CONWAY PLANNING COMMISSION

Planning and Development Staff Report

CONWAY CITY PLANNING DEPARTMENT REVIEW CASTLEBERRY MEADOWS SUBDIVISION PRELIMINARY PLAT

CONWAY CITY PLANNING DEPARTMENT REVIEW

Submitted Preliminary Plat

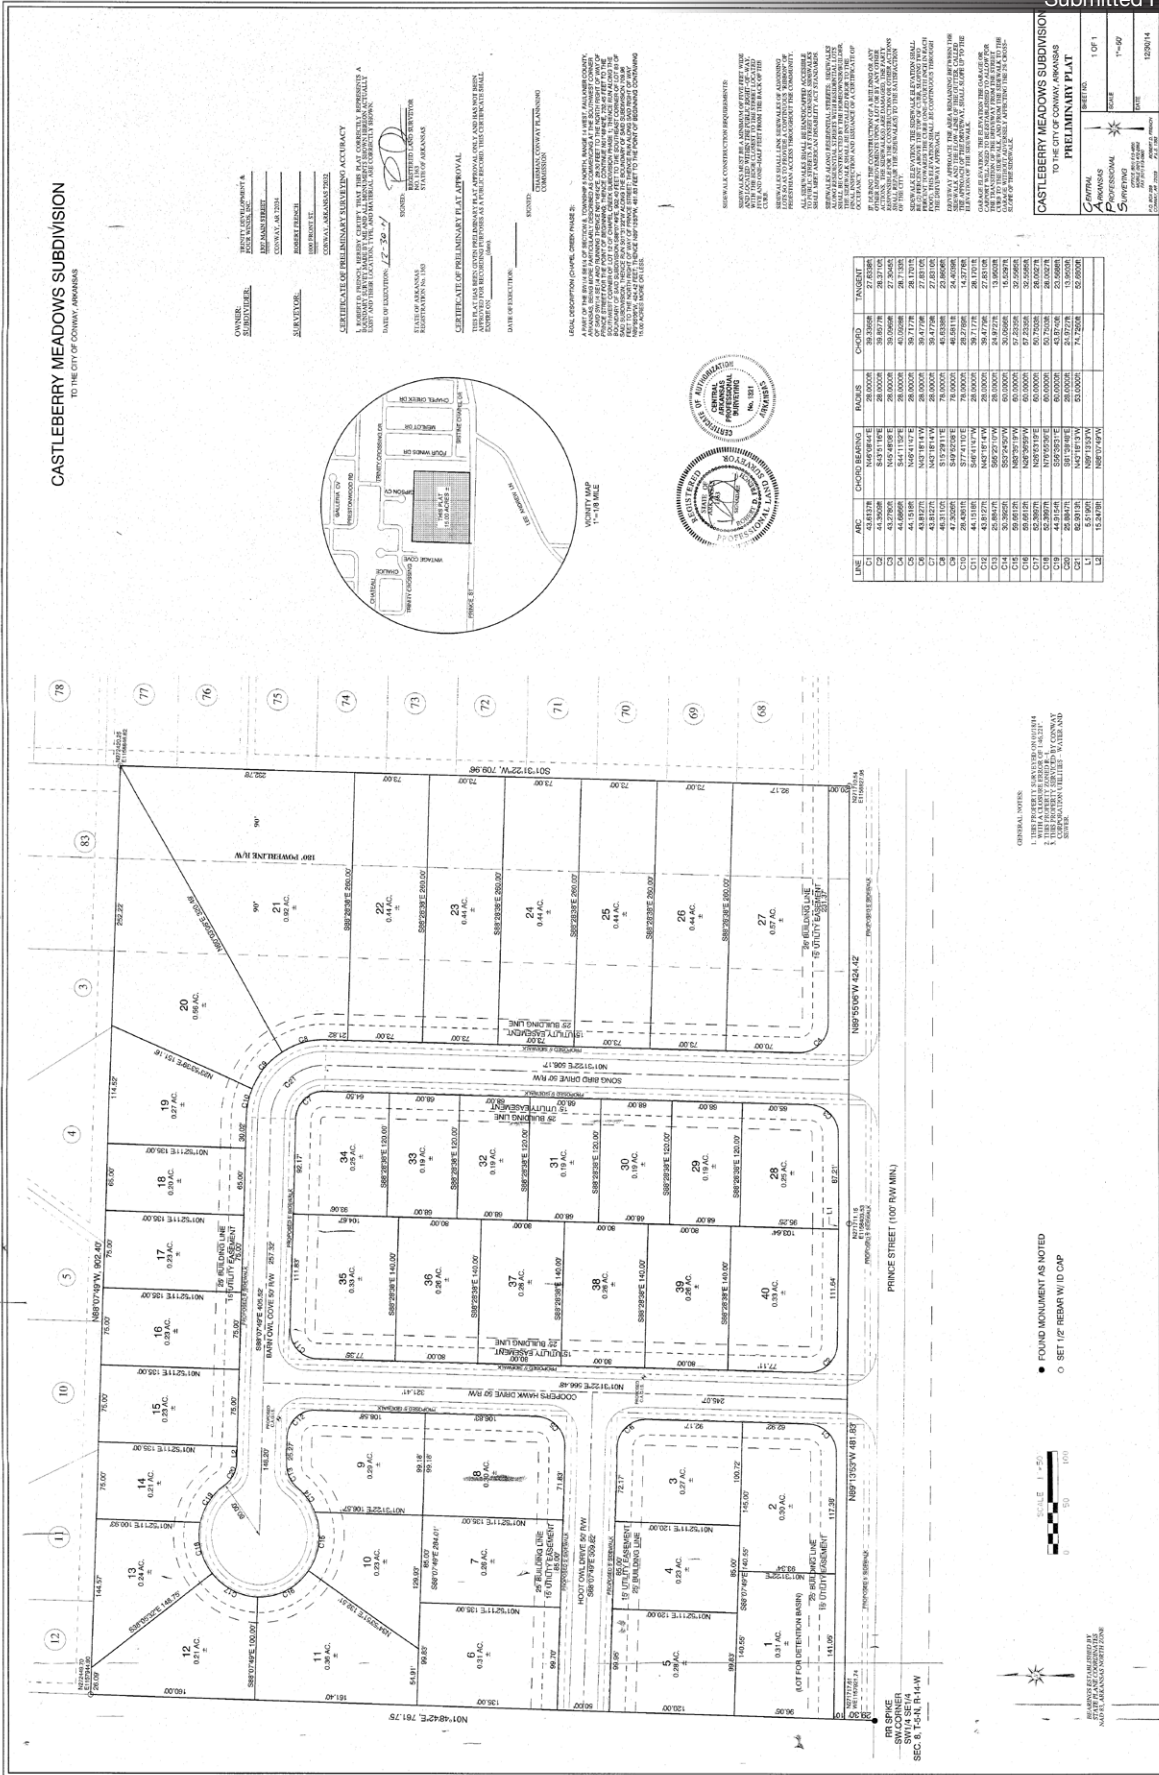
1. Street names that are not similar to existing street names are needed for all proposed streets. Bird Song Drive already exists inside city limits. Song Bird Drive will need to be changed to Gray Fox Drive. All other street names are approved.

2. The present zoning classification of the land to be subdivided and of the adjoining land contiguous to the boundary of the proposed subdivision is needed.
3. The layout of all proposed sidewalk systems are needed, along with relevant dimensions and bearings. The dimensions and bearings are needed for the sidewalk along Prince Street.

7. The development plans shall include and identify a prepared and dedicated flowage path or floodway that will accommodate a one hundred (100) year frequency storm event across and through the development. The floodway shall be uniformly graded along the length of the floodway such that water will not pond or accumulate on the surface due to humps or depressions along the route. Computations for the quantity

9. Minimum floor elevations shall be placed on the plat for all lots less than three (3) feet above the computed one hundred (100) year flood elevation. The minimum finished flood elevation shall be established at one (1) foot above the computed one hundred (100) year flood elevation. Minimum floor elevations as shown in the street & drainage plans must be shown on the plat.

11. The maximum number of single family and two family residential units served by a single access shall be thirty (30). For more than thirty (30) living units, there shall be no fewer than two (2) separate and approved fire apparatus access roads. These two access roads shall be placed a distance apart equal to not less than one half of the length of the maximum overall diagonal dimension of the property or area to be served, measured in a straight line between accesses. Fire Marshall, Kenny Wiedower, has no problems with the proposed access into the subdivision off Prince Street. *A request for variance has been received to allow the two access points to be less than half of the length of the maximum overall diagonal dimension of the property.* **The Planning Commission must approve this request or this condition must be corrected.**

12. State Fire Code 503.0.5 states that dead-end fire apparatus access roads in excess of 150 feet in length shall be provided with an approved area for turning around fire apparatus. Either a cul-de-sac or hammerhead turnaround must be provided at the west end of Hoot Owl Drive or lots 5 & 6 must be removed as buildable lots.

17. Due to the lack of pedestrian/vehicular connection between Castleberry Meadows Subdivision with Chapel Creek Subdivision to the north and east, the Planning Staff recommends a public crosswalk be provided between lots 20 & 21 or 21 & 22 to the required pedestrian pathway easement on the east side of lots 20-27. **The Planning Commission requires (does not require) the sidewalk easement between lots 20 & 21 or 21 & 22 to the required pedestrian pathway easement on the east side of lots 20-27.**

19. The subdivision must be annexed into the City of Conway and zoned R-1 before the filing of this plat.
20. In no case shall a lot be permitted where the lot is fronted by a stub-out or street termination. In such cases, dead-end fire apparatus turnarounds shall be provided. A turnaround must be provided at the west end of Hoot Owl Drive.
21. No lot shall be more than four times as deep as it is wide. *A variance has been received to allow lots 20-27 to be more than four times as deep as they are wide due to the 180' power transmission easement.* **The Planning Commission must approve this request or this condition must be corrected.**
22. Every lot must slope to a street or to a drainage easement.

24. The sidewalk location must be adjusted for Prince Street as located on the plat and in the Sidewalk Construction Requirements. The location of the sidewalk must be shown from the existing sidewalk along the south side of Chapel Creek Subdivision and then adjusted as required by the City Engineer and Planning Director.
25. Sidewalks along streets on unbuildable, green space, and other permanently vacant lots will be the responsibility of the developer. The developer will be responsible for the sidewalk along Prince Street for Lot 1 as a condition of filing this plat.

WINTERBROOK SUBDIVISION
 CITY OF ARKANSAS
LOT PLAN

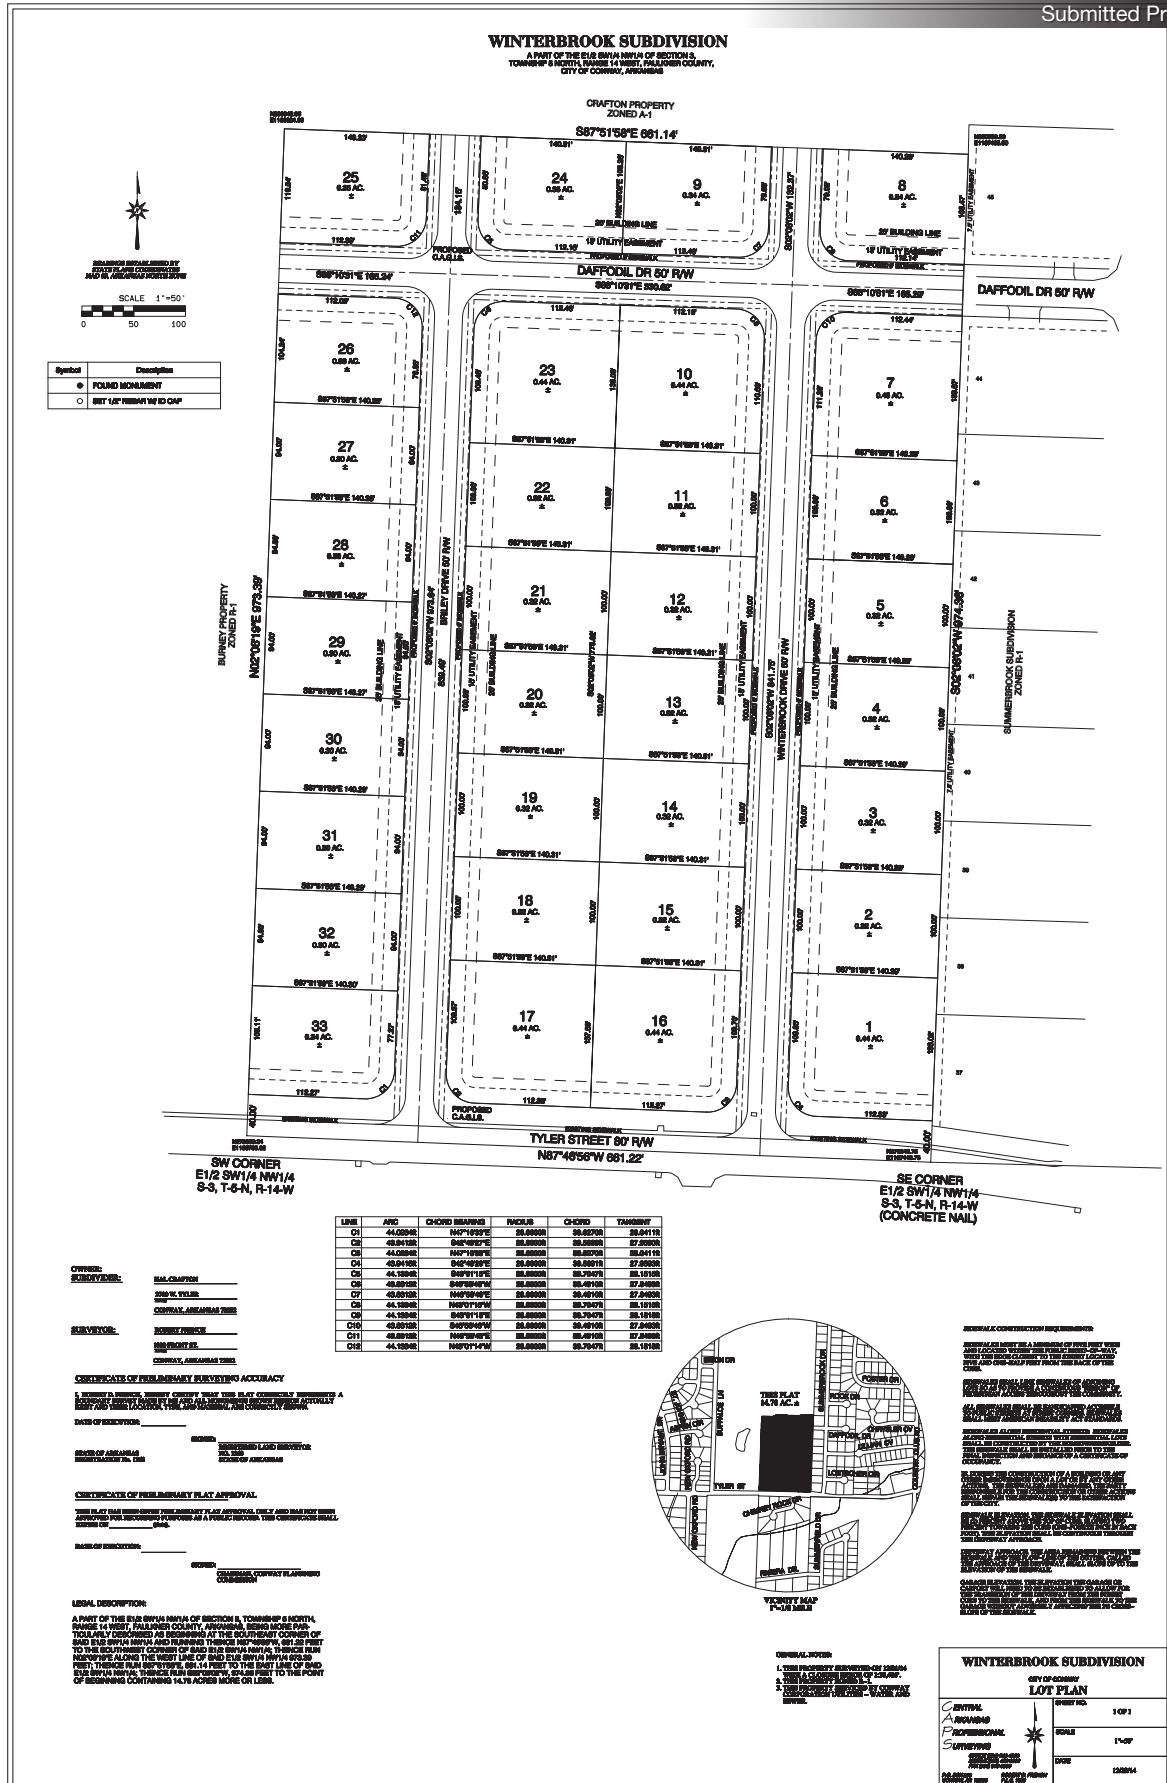
1. A phasing plan outlining the boundaries for each phase and the location of all CAGIS monuments for the subdivision is needed.
2. A minimum of two CAGIS monuments shall be placed in each subdivision or subdivision phase exceeding ten (10) acres. The southern proposed CAGIS monument must be moved to be not so far into the Tyler Street right-of-way to accommodate for Tyler Street widening.

4. The designers of residential streets are encouraged to lay them out to slow the use by through traffic. The Planning Commission may require that traffic calming techniques be employed. The Planning Staff and City Engineer recommends traffic calming be required along Briley Drive and Winterbrook Drive. **The Planning Commission requires (does not require) traffic calming on these streets.**

5. All methods to slow traffic must meet all relevant city regulations and must be approved by the City Engineer and the Planning Director. Multiple uses of traffic slowing methods are encouraged in an area.
6. Local street centerline offsets shall be no less than 125 feet. *A request for variance has been received to allow the offset for Winterbrook Drive and the existing Chimney Rock Drive to be 59.7 feet instead of the required 125 feet. The City Engineer and the Planning Staff have no problems with the variance since the left turn from the residential streets will not conflict and Chimney Rock Drive is such a small cul-de-sac. **The Planning Commission must approve this request or this condition must be corrected.***

10. Minimum lot width must conform with the requirements of the Zoning Ordinance. The zoning must be changed to comply with the lot width.
11. Minimum lot area must conform with the requirements of the Zoning Ordinance. The zoning must be changed to comply with the lot size.
12. The minimum building setback (building line) shall be no less than 25 feet from the right-of-way of the front street, or as required by the Zoning Ordinance. The building setback must meet the requirements of the zoning at time of filing.
13. Every lot must slope to a street or to a drainage easement.

14. Fire hydrants must be placed so that the furthest point of a lot in a residential subdivision is no more than 600 feet from the hydrant located on the same street. Variances must be approved by the Planning Commission and Fire Chief.
